CONNECTICUT SITING COUNCIL

RE: **DOCKET NO. 327** - The Connecticut Light and Power Company application for a Certificate of Environmental Compatibility and Public Need for the construction, maintenance, and operation of a proposed substation located off Commerce Park Drive, Oxford, Connecticut.

Revised comments have been received from the Department of Transportation. Revisions include a corrected project reference and an attached site plan. Copies are attached for your review.

RE: Docket 327 –Pursuant to C.G.S. 16-50/(a), Northeast Utilities Service Company, on behalf of The Connecticut Light and Power Company application for a certificate of Environmental Compatibility and Public Need for the construction, and operation of a substation facility located in a proposed industrial park in the Town of Oxford, Connecticut.

INNER APPROACH SURFACE DRAWING

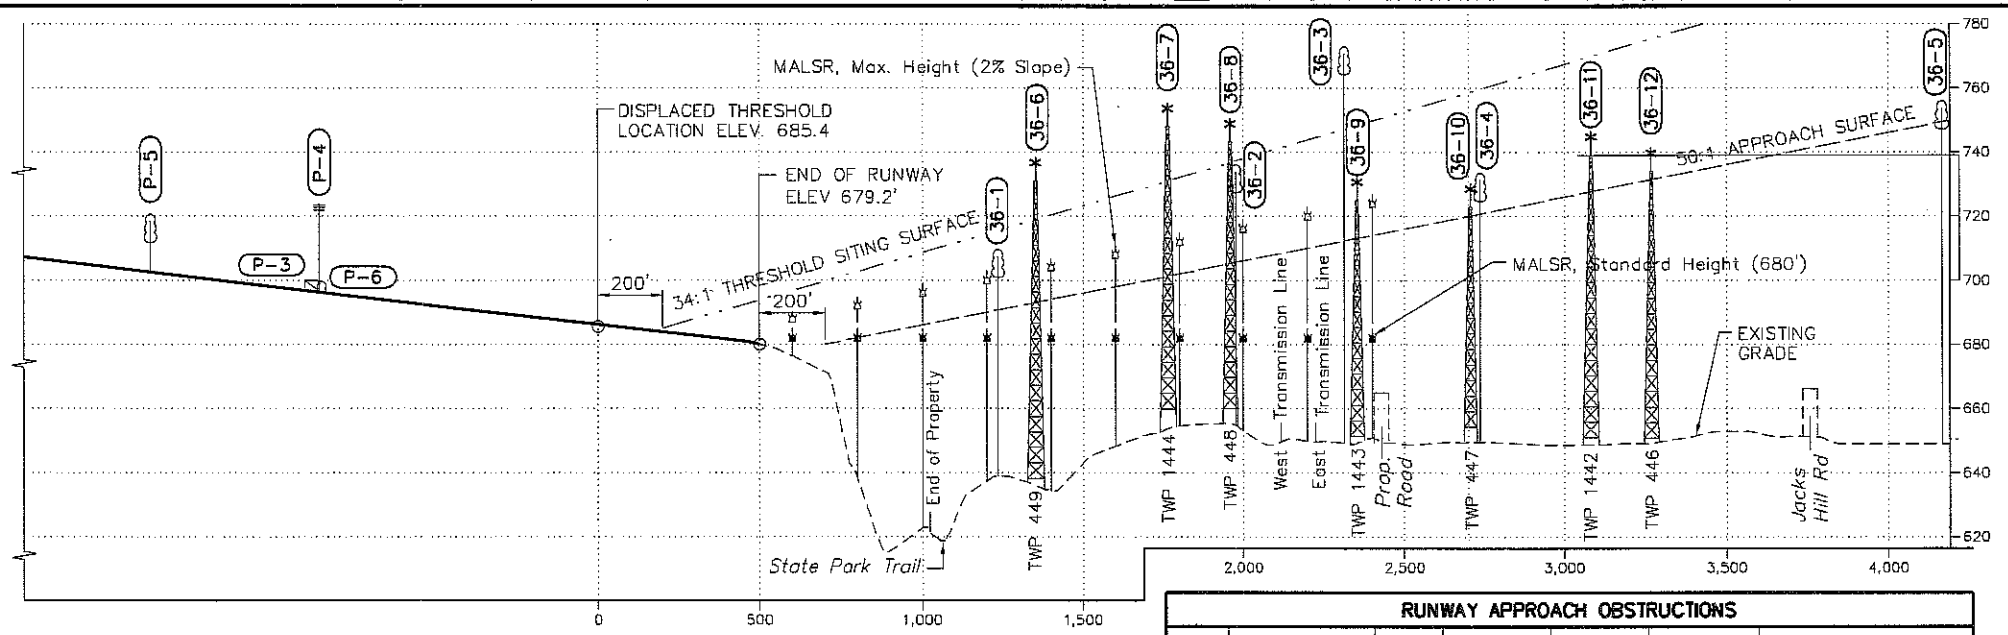
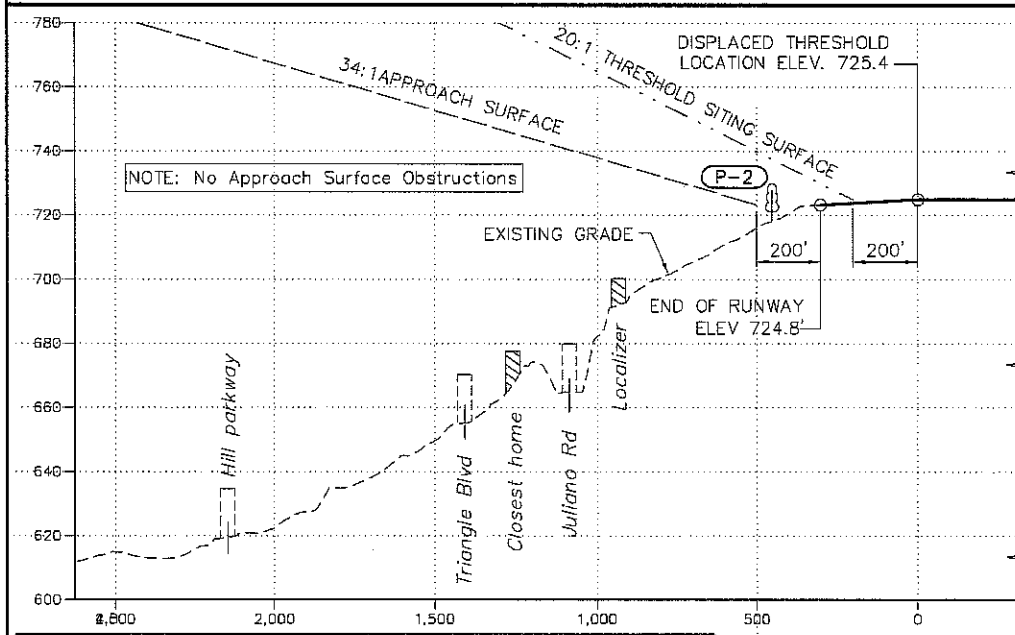
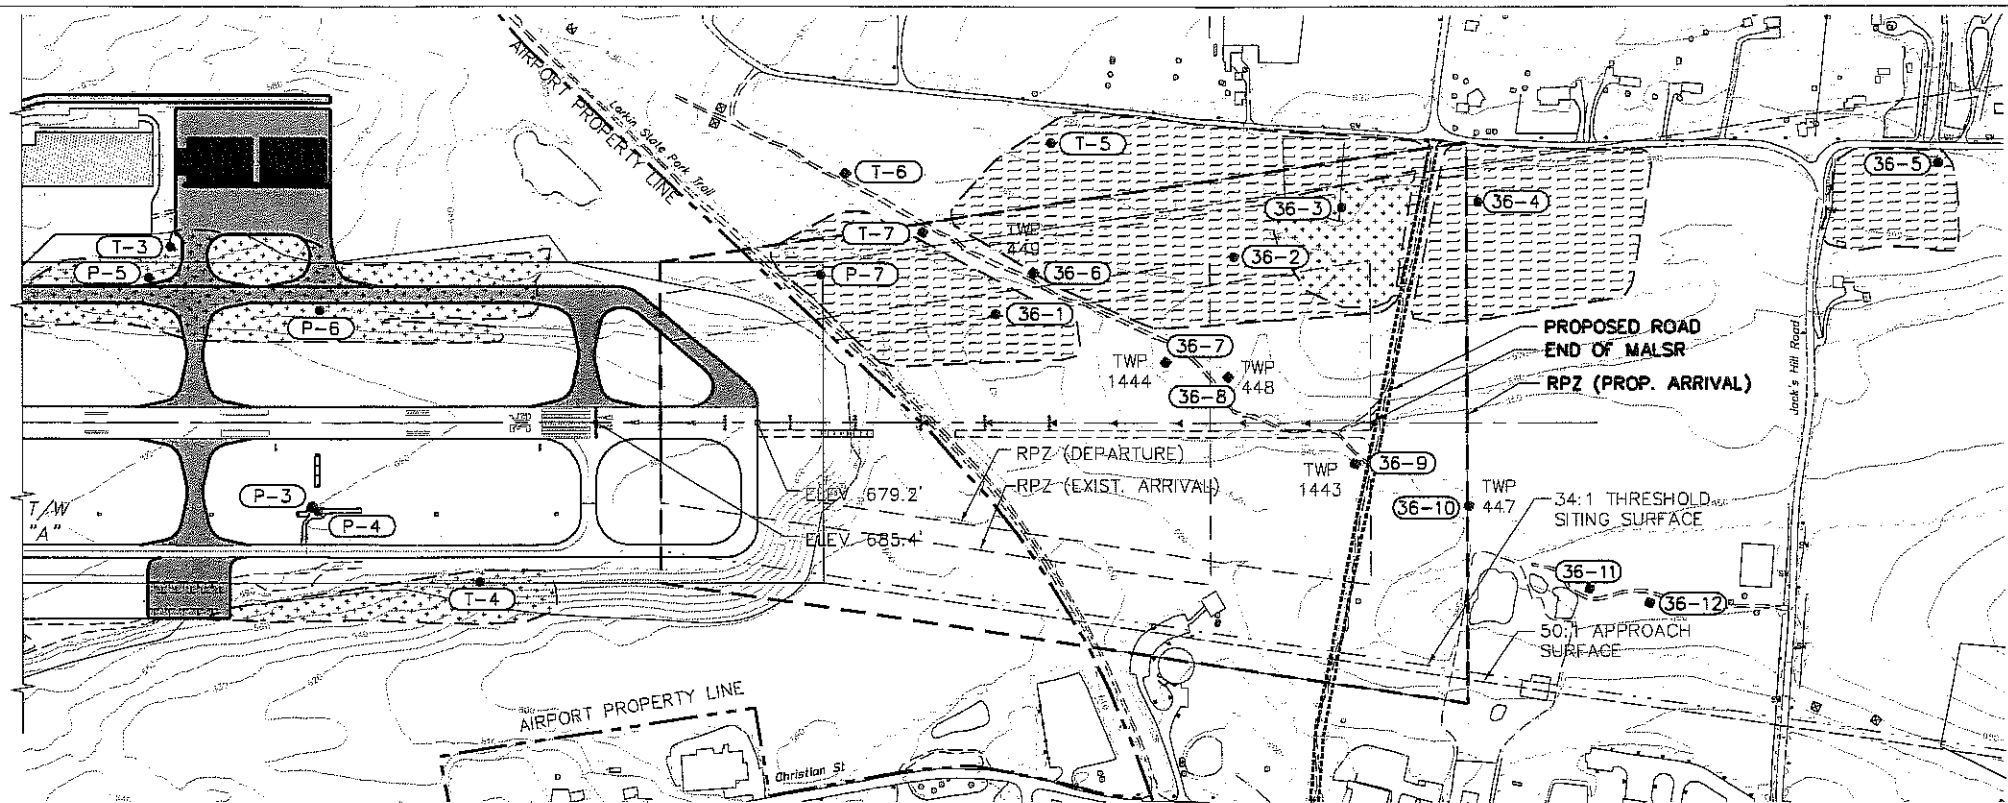
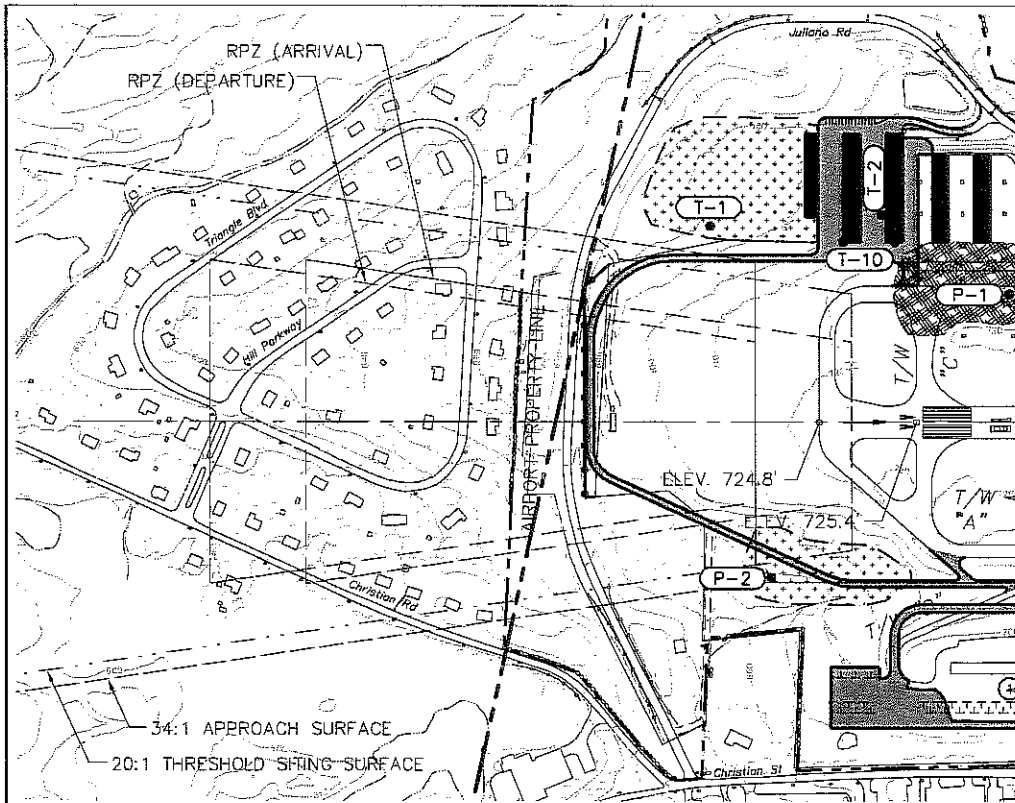
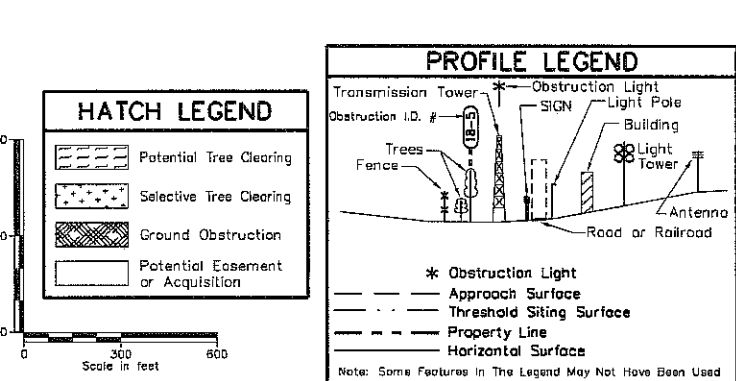
All proposed facilities (substation and poles) would be located within or adjacent to the existing and future Runway Protection Zone's of Runway 36, along the extended center line of Runway 36. The RPZ is a trapezoidal area located beyond the end of the runway end that should be controlled by the airport for the protection of people and property on the ground. (See FAA Advisory Circular 150-5100-13 Change 10.) While this in itself is not a prohibited land use, the FAA prefers that no development exist within the RPZ. Early in CL&P's planning process, the Department advised CL&P that the location as currently proposed in Docket 327 is not ideal, because it is within the RPZ.

FAA regulates airspace around all public use airports in the United States per Federal Aviation Regulation (FAR) Part 77 – "Objects Affecting Navigable Airspace". This FAR identifies a series of geometric plans (i.e. imaginary surfaces) that extend outward and upward from the Airport's runways and define obstruction clearing requirements. These surfaces identify the maximum acceptable height of objects by defining three-dimensional surfaces surrounding all sides of the airfield. When an object penetrates an imaginary surface, it is considered an airspace obstruction, and may present a hazard to air navigation. These surfaces include the Approach Surface, as well as related design standard such as the Threshold Siting Surfaces (TSS). These surfaces are longitudinally centered on the extended runway centerlines, extending outward and upward from the ends of the primary surface. For Runway 36 the Approach Surface is 50:1 and the TSS is 34:1. (See the attached Airport Layout Plan drawing and Inner Approach.)

While the proposed substation itself is located beneath the precision FAR Part 77 Approach Surface to Runway 36 at OXC, the existing towers and their accompanying power lines that will be modified to connect with the substation do penetrate the FAR Part 77 Approach Surface and Threshold Siting Surface (TSS). Although these towers are equipped with obstruction lighting, removal or lowering of the towers and their accompanying power lines out of the Approach and Threshold Siting Surfaces is recommended to improve safety. CL&P has been requested by ConnDOT to determine the feasibility of removing these Towers and their accompanying power lines from the Approach Surface and TSS. However, no mention of this feasibility has been made in their submittal to the siting council.

The Department cannot support the construction of this substation in its present location due to CL&P's failure to study and report on their ability remove the power lines from the FAR Part 77 Approach Surface and the TSS at OXC airport and to prove any increase in electronic noise will not have an adverse effect on OXC's landing aids.
